BCA ASSESSMENT REPORT

**Aspect Industrial Estate
Lots 54-58 Mamre Road, Kemps Creek
Warehouse 1 (Lot 1)**

**Prepared For:
Mirvac**

Revision 52

Figure 1 – Warehouse 1 Perimeter Vehicular Access per BCA C2.4.

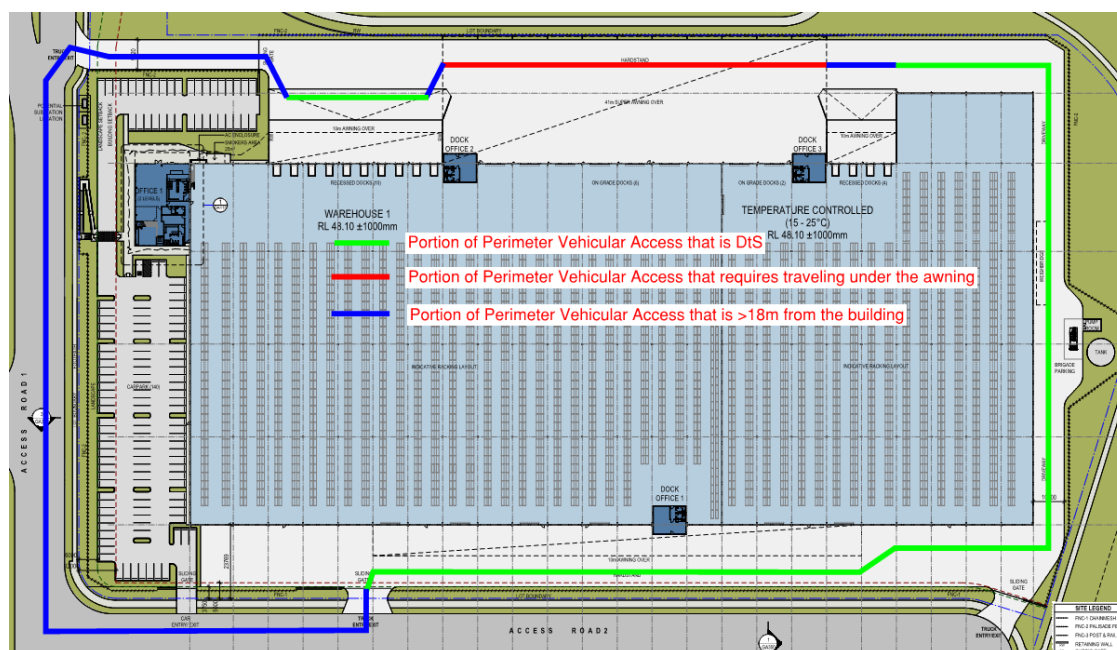
Comments: The proposed building does not comply with the provisions of C2.4 and thus the following non-compliance issues are required to be addressed as a Performance Solution by the Fire Engineer to demonstrate compliance with Performance Requirement CP9:

- + *Perimeter Vehicular Access is greater than 18m from various parts of the building.*
- + *Perimeter Vehicular Access requires traveling under the super awning on the western side of the building.*

Note 1: Any proposed gates are to achieve no less than 6m unobstructed width or the reduced width will need to be included in the above Performance Solution.

Note 2: The driveways providing vehicular perimeter access must be designed with adequate loading capacities to withstand a fire truck and the gradients of any ramps and swept paths should take into consideration the requirements of the FRNSW Fire Safety Guideline – Access for Fire Brigade Vehicles and Firefighters.
